Submission by Washington DC Ward Two and Three to the FAA for  
Modifications to the Proposed LAZIR B Departure Procedure (Revised)

November 1, 2016

# DC Proposal

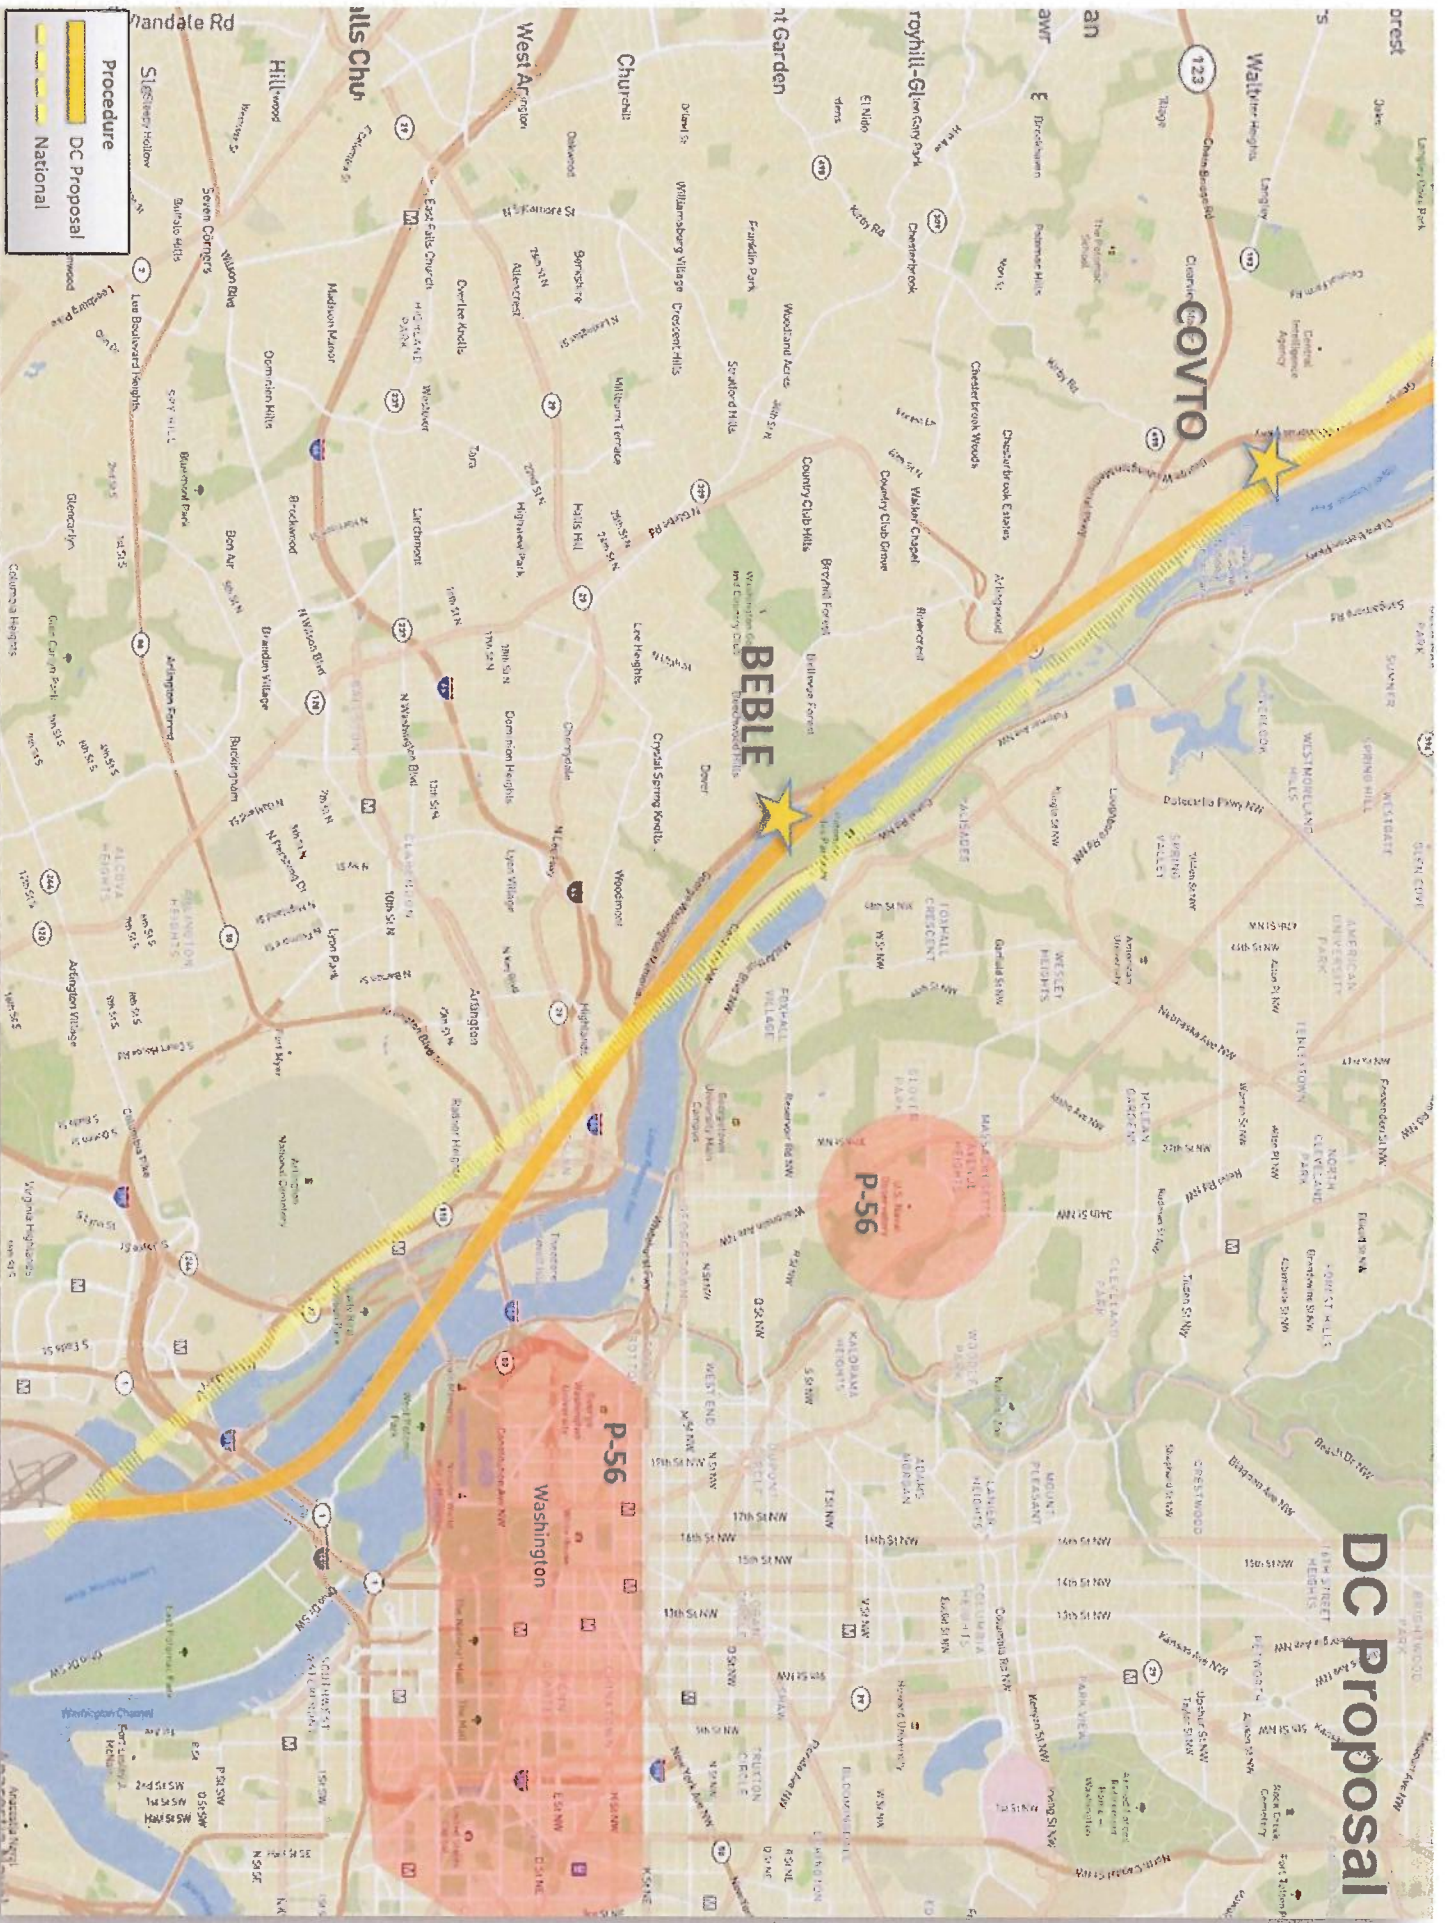
We therefore propose two adjustments to the LAZIR B departure procedure. First instead of bringing planes over the river extremely close to the Prohibited Zone (P-56) and then over Georgetown we propose that that the first waypoint named ADAXE be eliminated and that aircraft make their way to BEBLE as the first point. The location of BEBLE would be the same as proposed in LAZIR B close to the Georgetown Reservoir. The next waypoint COVTO would use the current location of COVTO instead of moving it east as proposed in LAZIR B. This combination of new and old waypoints would require planes after takeoff to make a sharp turn to the west and head in a straight line to BEBLE. At our request the FAA confirmed that such a flight path was flyable and provided us with the attached schematic of this flight path (in orange) compared with the NATIONAL 328 in yellow.

First, the current LAZIR flight path follows a figure S pattern which increases aircraft noise because of the turns at ADXE and BEBLE. The proposed modification of LAZIR B would create a straighter flight path similar to the NATIONAL 328 which should decrease aircraft noise on both sides of the river.

Second, planes can climb faster when flying in a straight line as opposed to constantly turning so the proposed flight path would facilitate planes gaining altitude sooner which also impacts the amount of aircraft noise on the ground. Straight line flight also uses less fuel and produces less pollution both of which are goals of the Next Gen Act which the FAA is supposed to consider in designing flight paths.

Finally, the proposed modification of LAZIR B moves the flight path further away from P-56, which includes the White House and the National Monuments on the Mall, which are currently being subjected to significant aircraft noise and pollution as planes turn left approaching ADAXE.
